NEEDS ASSESSMENT AND LEVEL OF SERVICE EVALUATION

APPENDIX D: AMERICANS WITH DISABILITIES ACT (ADA) FACILITY BARRIER REPORT

Americans with Disabilities Act (ADA) Facility Barrier Report

For Selected Park Sites

Pat Pfeifer Park

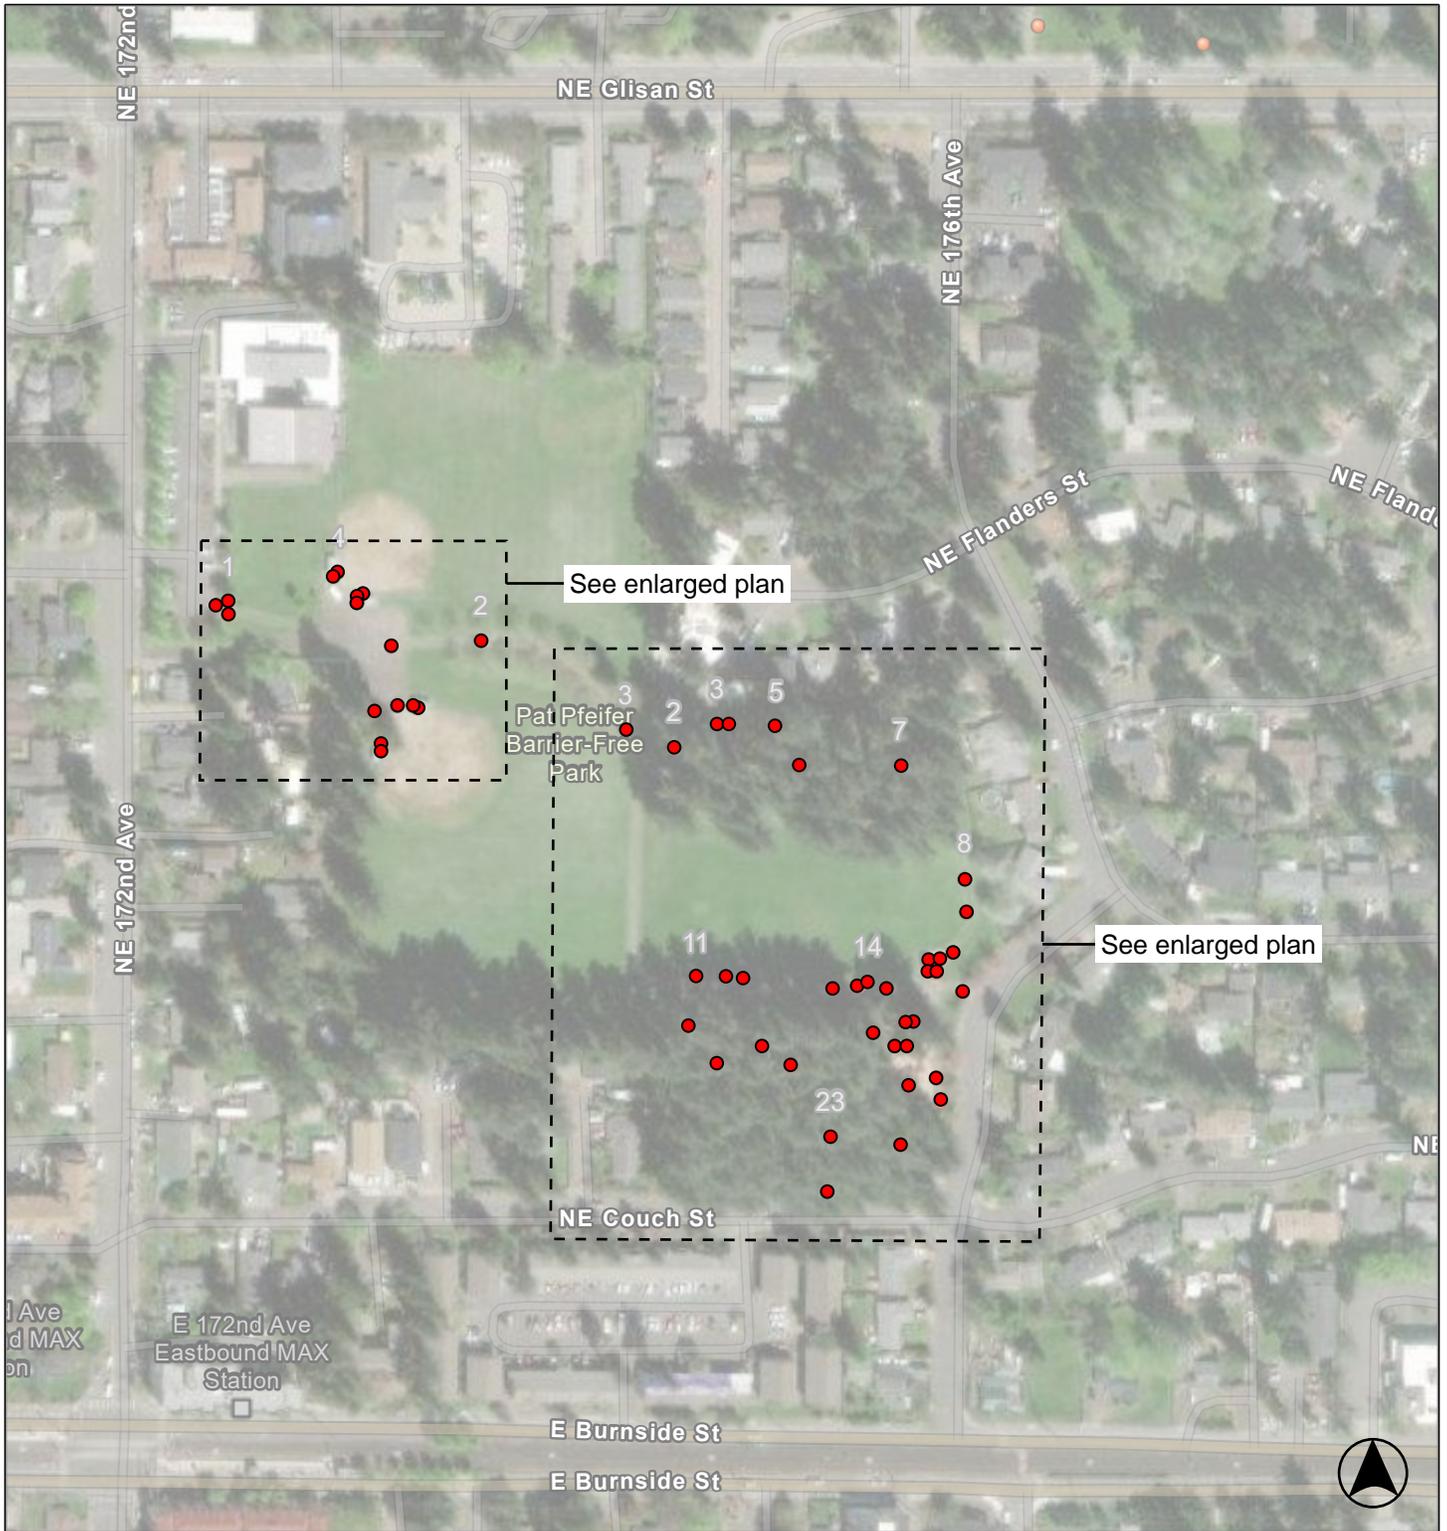
Park		
1 - 1	Parking Area	Category: 1
Regrade accessible parking space or access aisle		\$4,050
Notes: Slopes of accessible parking space and access aisle are up to 6.2% (2.0% max).		
ADA: 502.4		
Other: -		
Provide adequate striping		\$180
Notes: The words "No Parking" are not painted in the access aisle.		
ADA: -		
Other: OSSC 1106.7		
Reduce or eliminate opening		\$300
Notes: Surface of parking area has opening greater than 1/2" due to stormwater drain grate (Max 1/2" openings permitted).		
ADA: 302.3		
Other: -		
Install van accessible sign		\$1,750
Notes: A "Van Accessible" sign is not provided ("Van Accessible" sign that is 18" wide by 9" high on a white retroreflective background and green retroreflective lettering provided at each van accessible space).		
ADA: 208.2.4, 502.6		
Other: OSSC 1106.7		
Provide a pavement stencil		\$310
Notes: Paint is not retroreflective and is fading.		
ADA: -		
Other: OSSC 1106.7

Park	
4 - 2	Walk Category: 1
Regrade surface	\$2,800
Notes: Cross slope of concrete path is up to 5.2% for 28 linear feet (2.0% max).	
ADA: 403.3	
Other: -	
4 - 3	Walk Category: 1
Grind or patch vertical change of grade	\$100
Notes: Surface level change is 1/2" due to loose bricks (1/4" max; up to 1/2" with a 1:2 bevel).	
ADA: 303.2, 303.3	
Other: -	
4 - 4	Walk Category: 1
Regrade surface	\$4,000
Notes: Cross slope of concrete path is up to 4.5% for 40 linear feet (2.0% max).	
ADA: 403.3	
Other: -	
4 - 5	Walk Category: 1
Grind or patch vertical change of grade	\$100
Notes: Surface level change is 1/2" due to loose bricks (1/4" max; up to 1/2" with a 1:2 bevel).	
ADA: 303.2, 303.3	
Other: -	
4 - 6	Walk Category: 1
Grind or patch vertical change of grade	\$100
Notes: Surface level change is 1/2" due to loose bricks (1/4" max; up to 1/2" with a 1:2 bevel).	
ADA: 303.2, 303.3	
Other: -	
4 - 7	Walk Category: 1
Grind or patch vertical change of grade	\$100

Notes: Surface level change is 1/2" due to loose bricks (1/4" max; up to 1/2" with a 1:2 bevel).	
ADA: 303.2, 303.3	
Other: -

Park		
4 - 12	Walk	Category: 1
Regrade surface		\$25,200
Notes: Running slope of concrete is up to 10.8% for 12 linear feet (5.0% max).		
Cross slope of concrete is up to 7.5% for 240 linear feet (2.0% max).		
ADA: 403.3		
Other: -		
Grind or patch vertical change of grade		\$500
Notes: Surface level change is 3/4" at concrete joint (1/4" max; up to 1/2" with a 1:2 bevel). (x5)		
ADA: 303.2, 303.3		
Other: -		
Reduce or eliminate opening		\$900
Notes: Gap at concrete joint is 1-1/2" (1/2" max).(x3)		
ADA: 302.3		
Other: -		
8 - 1	Door/Gate	Category: 1
Provide or modify door kick plate		\$350
Notes: A smooth and uninterrupted kick plate surface is not provided. Chain-link is located in the 10" space above the finish floor.		
ADA: 404.2.10		
Other: -		
Increase or provide clear floor space		\$1,270
Notes: An exterior landing is not provided at the gate (30" by 48" min).		
ADA: 305.2, 305.3, 305.5		
Other: -		
8 - 2	Door/Gate	Category: 1

Provide or modify door kick plate		\$350
Notes: A smooth and uninterrupted kick plate surface is not provided. Chain-link is located in the 10" space above the finish floor.		
ADA: 404.2.10		
Other: -		
Increase or provide clear floor space		\$1,270
Notes: An exterior landing is not provided at the gate (30" by 48" min).		
ADA: 305.2, 305.3, 305.5		
Other: -

Park	
8 - 3	Door/Gate Category: 1
Provide or modify door kick plate	\$350
Notes: A smooth and uninterrupted kick plate surface is not provided. Chain-link is located in the 10" space above the finish floor.	
ADA: 404.2.10	
Other: -	
Replace or modify door threshold	\$160
Notes:	
ADA: 404.2.5	
Other: -	
8 - 4	Door/Gate Category: 1
Provide or modify door kick plate	\$350
Notes: A smooth and uninterrupted kick plate surface is not provided. Chain-link is located in the 10" space above the finish floor.	
ADA: 404.2.10	
Other: -	
Replace or modify door threshold	\$160
Notes: Transition onto ballfield surface has a vertical drop greater than 1/2" (max 1/4" vertical or 1/2" with 1:2 bevel).	
ADA: 404.2.5	
Other: -	
8 - 5	Door/Gate Category: 1
Provide or modify door kick plate	\$350
Notes: A smooth and uninterrupted kick plate surface is not provided. Chain-link is located in the 10" space above the finish floor.	
ADA: 404.2.10

Other: -	
Increase or provide clear floor space	\$1,270
Notes: An exterior landing is not provided at the gate (30" by 48" min).	
ADA: 305.2, 305.3, 305.5	
Other: -

Park	
8 - 6	Door/Gate Category: 1
Provide or modify door kick plate	\$350
Notes: A smooth and uninterrupted kick plate surface is not provided. Chain-link is located in the 10" space above the finish floor.	
ADA: 404.2.10	
Other: -	
Replace or modify door threshold	\$160
Notes: Transition onto ballfield surface has a vertical drop greater than 1/2" (max 1/4" vertical or 1/2" with 1:2 bevel).	
ADA: 404.2.5	
Other: -	
8 - 7	Door/Gate Category: 1
Provide or modify door kick plate	\$350
Notes: A smooth and uninterrupted kick plate surface is not provided. Chain-link is located in the 10" space above the finish floor.	
ADA: 404.2.10	
Other: -	
Increase or provide clear floor space	\$1,270
Notes: An exterior landing is not provided at the gate (30" by 48" min).	
ADA: 305.2, 305.3, 305.5	
Other: -	
8 - 8	Door/Gate Category: 1
Provide or modify door kick plate	\$350
Notes: A smooth and uninterrupted kick plate surface is not provided. Chain-link is located in the 10" space above the finish floor.

ADA: 404.2.10	
Other: -	
Replace or modify door threshold	\$160
Notes: Transition onto ballfield surface has a vertical drop greater than 1/2" (max 1/4" vertical or 1/2" with 1:2 bevel).	
ADA: 404.2.5	
Other: -

Park	
8 - 9	Door/Gate Category: 1
Replace or modify door threshold	\$160
Notes: Threshold is not beveled (1/4" max; up to 1/2" with a 1:2 bevel).	
ADA: 404.2.5	
Other: -	
Adjust door closer	\$160
Notes: Door closer sweep time is less than the five second minimum from 90 degrees to 12 degrees.	
Door opening force is 6 lbs (5 lbs max).	
ADA: 404.2.8.1, 404.2.9	
Other: OSSC 1102.1.2.5	
Regrade surface	\$625
Notes: Slope of the exterior landing is 5.6% (2.0% max).	
ADA: 404.2.4.4	
Other: -	
8 - 10	Door/Gate Category: 1
Adjust door closer	\$160
Notes: Door closer sweep time is less than the five second minimum from 90 degrees to 12 degrees.	
ADA: 404.2.8.1	
Other: -	
Regrade surface	\$625
Notes: Slope of the exterior landing is 9.1% (2.0% max).	
ADA: 404.2.4.4	
Other: -	
10 - 1	Drinking Fountain Category: 3
Confirm water flow compliance	\$0
Notes: Water service to the drinking fountain was disconnected at the time of the assessment. Flow height and angle could not be confirmed.

Park	
20 - 1	Single User Restroom
Category: 2	
Install restroom sign	\$250
Notes: Replace sign - the tactile elements are broken, the braille is not located beneath the letters. The word "restroom" is not tactile.	
ADA: 216.8	
Other: -	
Replace or reposition mirror	\$160
Notes: Bottom of the mirror's reflecting surface above the lavatory is 40-1/4" AFF (40" max).	
ADA: 603.3	
Other: -	
Increase water closet clear width or depth	\$840
Notes: Clear width over water closet is 59" (60" min) to the side wall.	
ADA: 604.3.1, 604.8.1	
Other: -	
Replace or reposition fixtures	\$1,590
Notes: The water closet centerline is 18-1/2" from the wall (16" min to 18" max).	
ADA: 604.2	
Other: -	
Modify operating mechanism	\$320
Notes: Operating effort of the soap dispenser is 6 lbs (5 lbs max).	
ADA: 309.4	
Other: -	
Confirm water flow compliance	\$0
Notes: Water service to the lavatory was disconnected at the time of the assessment. Force to operate and water metering could not be confirmed.

Park	
20 - 2	Single User Restroom Category: 2
Install restroom sign	\$250
Notes: Replace sign - the tactile elements are broken, the braille is not located beneath the letters. The word "restroom" is not tactile.	
ADA: 216.8	
Other: -	
Modify operating mechanism	\$640
Notes: Operating effort of soap dispenser is 8 lbs (5 lbs max).	
ADA: 309.4	
Other: -	
Replace or reposition fixtures	\$1,590
Notes: The water closet centerline is 18-1/2" from the wall (16" min to 18" max).	
ADA: 604.2	
Other: -	
Replace or adjust water controls	\$640
Notes: Operating effort of lavatory faucet is 6 lbs (5 lbs max).	
ADA: 309.4, 606.4	
Other: -	
29 - 1 Game and Sports Area Category: 2	
Provide an accessible route	\$3,200
Notes: An accessible route to the baseball area is not provided. Route from the path to the baseball is 40 linear feet over grass.	
ADA: 206.2.2	
Other: -	
Provide wheelchair seating	\$1,800
Notes: Wheelchair seating is not provided. (2 wheelchair spaces min for 40 seats).

ADA: 221.2.1.1	
Other: -	
29 - 2 Game and Sports Area Category: 2	
Provide an accessible route	\$3,200
Notes: An accessible route to the baseball area is not provided. Route from the path to the baseball is 40 linear feet over grass.	
ADA: 206.2.2	
Other: -	
Provide wheelchair seating	\$1,800
Notes: Wheelchair seating is not provided. (2 wheelchair spaces min for 40 seats).	
ADA: 221.2.1.1	
Other: -

Park	
33 - 2	Outdoor Constructed Features Category: 3
Increase or provide clear floor area	\$600
Notes: A clear ground space is not provided adjacent to the bench (36" by 48" min). (x3)	
ADA: -	
Other: ABA 1011.2.1, ABA 1011.2.3	
33 - 3	Outdoor Constructed Features Category: 3
Increase or provide clear floor area	\$200
Notes: A clear floor space is not provided at the trash container opening (36" by 60" min parallel approach or 36" by 48" min forward approach). Container is 42" from the path.	
ADA: -	
Other: ABA 1011.2	
33 - 4	Outdoor Constructed Features Category: 3
Increase or provide clear floor area	\$400
Notes: A clear ground space is not provided adjacent to the bench (36" by 48" min). (x2)	
ADA: -	
Other: ABA 1011.2.1, ABA 1011.2.3	
33 - 5	Outdoor Constructed Features Category: 3
Increase or provide clear floor area	\$200
Notes: A clear floor space is not provided at the trash container opening (36" by 60" min parallel approach or 36" by 48" min forward approach). Container is 40" from the path.

ADA: -	
Other: ABA 1011.2	
33 - 6	Outdoor Constructed Features Category: 3
Increase or provide clear floor area	\$200
Notes: Clear ground space adjacent to the trash can has a slope of 7.4% (2.0% max).	
ADA: -	
Other: ABA 1011.2	
33 - 7	Outdoor Constructed Features Category: 3
Increase or provide clear floor area	\$200
Notes: A clear floor space is not provided at the trash container opening (36" by 60" min parallel approach or 36" by 48" min forward approach). Broken and uneven pavement in the clear floor space.	
ADA: -	
Other: ABA 1011.2.1, ABA 1011.2.3

Park	
33 - 8	Outdoor Constructed Features Category: 3
Increase or provide clear floor area	\$200
Notes: A clear ground space is not provided adjacent to the bench (36" by 48" min). The surface is gravel.	
ADA: -	
Other: ABA 1011.2.1, ABA 1011.2.3	
33 - 9	Outdoor Constructed Features Category: 3
Increase or provide clear floor area	\$200
Notes: A clear ground space is not provided adjacent to the bench (36" by 48" min).	
ADA: -	
Other: ABA 1011.2.1, ABA 1011.2.3	
33 - 10	Outdoor Constructed Features Category: 3
Increase or provide clear floor area	\$200
Notes: A clear floor space is not provided at the trash container opening (36" by 60" min parallel approach or 36" by 48" min forward approach). Container is 37" from the path.	
ADA: -	
Other: ABA 1011.2	
33 - 11	Outdoor Constructed Features Category: 3
Increase or provide clear floor area	\$200
Notes: A clear floor space is not provided at the trash container opening (36" by 60" min parallel approach or 36" by 48" min forward approach). Container is 42" from the path.

ADA: -	
Other: ABA 1011.2	
35 - 1	Other Category: 3
Increase or provide maneuvering or clear floor area	\$200
Notes: Slope of the dog bag station clear floor space is 3.1% (2.0% max).Pavers are loose and uneven.	
ADA: 305.2, 305.3, 305.5	
Other: -

Park	
47 - 1 Trails	Category: 2
Regrade surface	\$840
Notes: Cross slope of path is up to 3.9% for 14 linear feet (2.0% max).	
ADA: -	
Other: ABA 1017.7.2	
Install sign	\$250
Notes: Provide trail sign including length of the trail or trail segment, surface type, typical an dminimum tread width, typical and maximum running slope, and typical and maximum cross slope.	
ADA: -	
Other: ABA 1017.10	
47 - 2 Trails	Category: 2
Regrade surface	\$600
Notes: Cross slope of path is up to 4.0% for 10 linear feet (2.0% max).	
ADA: -	
Other: ABA 1017.7.2	
47 - 3 Trails	Category: 2
Regrade surface	\$600
Notes: Cross slope of path is up to 3.8% for 10 linear feet (2.0% max).	
ADA: -	
Other: ABA 1017.7.2	
Reduce or eliminate opening	\$300
Notes: Gap at crack in surface is greater than 1/2" (1/2" max).	
ADA: 302.3	
Other: ABA 1017.6	
47 - 4 Trails	Category: 2
Regrade surface	\$2,280
Notes: Cross slope of path is up to 3.8% for 38 linear feet (2.0% max).

Park	
47 - 9 Trails	Category: 2
Regrade surface	\$300
Notes: Run slope of path is up to 13.0% for 5 linear feet (12.0% max).	
ADA: -	
Other: ABA 1017.7.1	
Install sign	\$250
Notes: Provide trail sign including length of the trail or trail segment, surface type, typical and minimum tread width, typical and maximum running slope, and typical and maximum cross slope.	
ADA: -	
Other: ABA 1017.10	
47 - 10 Trails	Category: 2
Regrade surface	\$2,940
Notes: Cross slope of path is up to 5.0% for 49 linear feet (2.0% max).	
ADA: -	
Other: ABA 1017.7.2	
Reduce or eliminate opening	\$300
Notes: Gap at cracks is greater than 1/2" (1/2" max).	
ADA: 302.3	
Other: ABA 1017.6	
47 - 11 Trails	Category: 2
Regrade surface	\$2,400
Notes: Cross slope of path is up to 9.9% for 37 linear feet (2.0% max).	
ADA: -	
Other: ABA 1017.7.2	
47 - 12 Trails	Category: 2
Regrade surface	\$3,840
Notes: Cross slope of path is up to 8.5% for 64 linear feet (2.0% max).

ADA: -	
Other: ABA 1017.7.2	
Install sign	\$250
Notes: Provide trail sign including length of the trail or trail segment, surface type, typical and minimum tread width, typical and maximum running slope, and typical and maximum cross slope.	
ADA: -	
Other: ABA 1017.10

Park	
47 - 13 Trails	Category: 2
Regrade surface	\$2,520
Notes: Cross slope of path is up to 4.2% for 42 linear feet (2.0% max).	
ADA: -	
Other: ABA 1017.7.2	
47 - 14 Trails	Category: 2
Regrade surface	\$1,140
Notes: Cross slope of path is up to 7.6% for 19 linear feet (2.0% max).	
ADA: -	
Other: ABA 1017.7.2
